Public Service Commission

August 7, 2015

The Reclamation Division has reviewed Coteau's July 6, 2015 response to our May 20, 2015 technical review letter for Revision 18 to Permit NACT-0201. The following issues must be resolved prior to this office recommending Commission action.

Figure 1: NE1/4 of Section 15, T145N, R88W

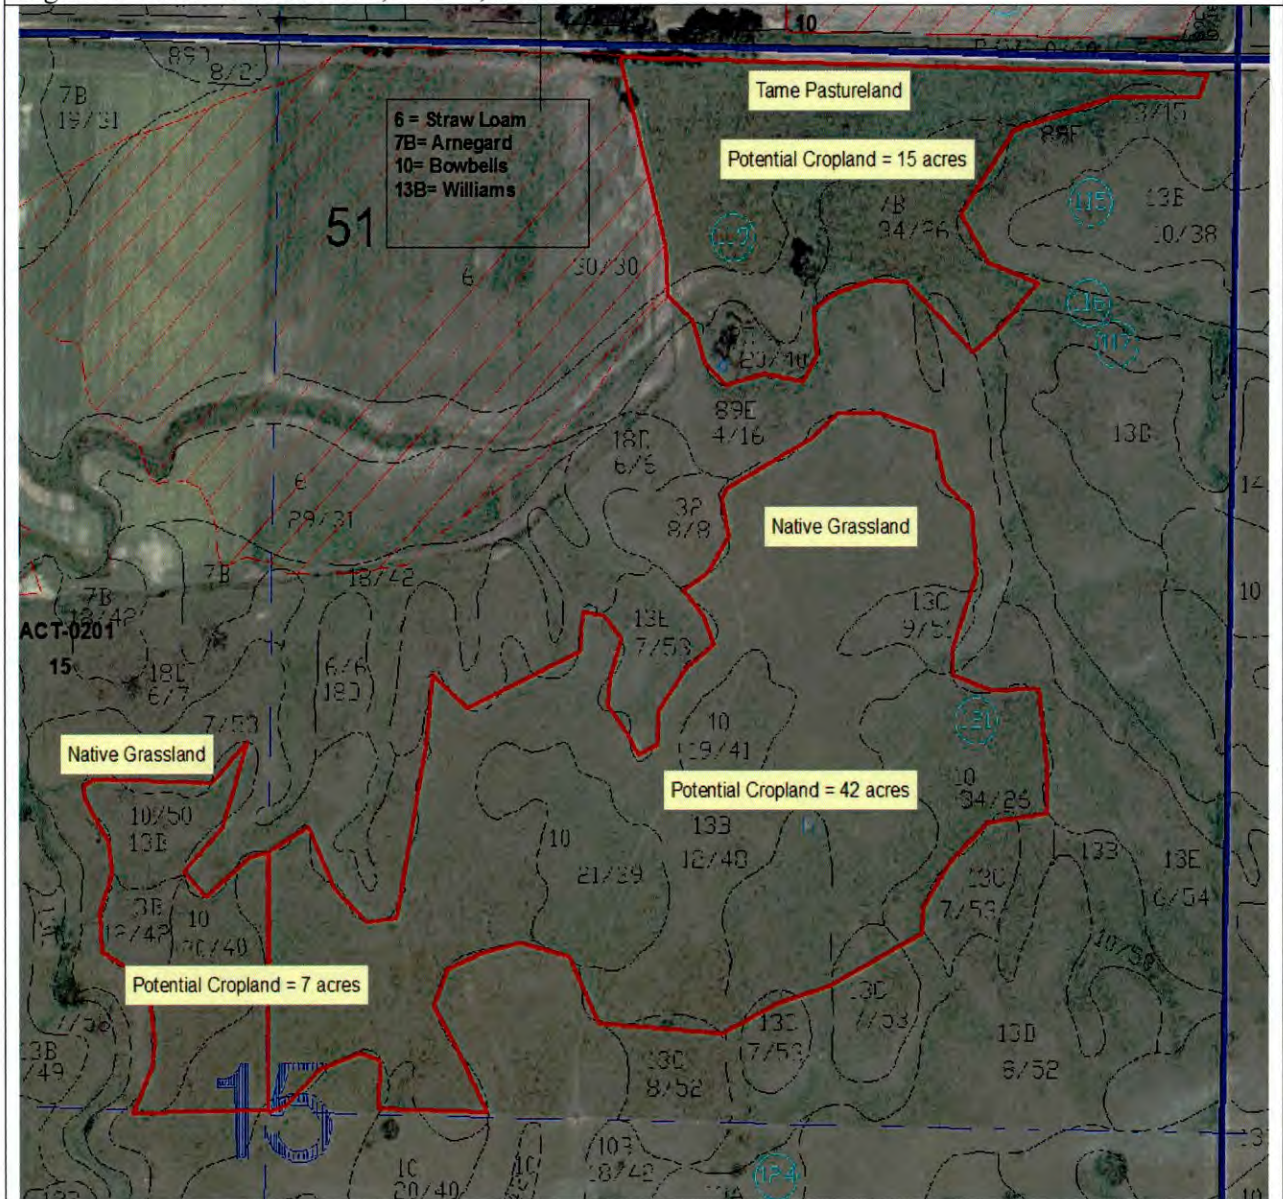
17. Follow-up to Item 37: The Reclamation Division has reviewed the pre-mine land use capabilities of the non-cropland/hayland areas that will be disturbed through the current mine plan period, 2034, and has determined that an area of native grassland and tame pastureland comprising about 64 acres located in the NE1/4 of Section 15 is potential cropland. Therefore, please revise the permit to address restoring the pre-mine capabilities of this acreage as required by NDCC 38-14.1-24(2). This can be accomplished by identifying an area of similar size in the NE1/4 of Section 15 where suitable topsoil depths will be restored and slopes no steeper than that which
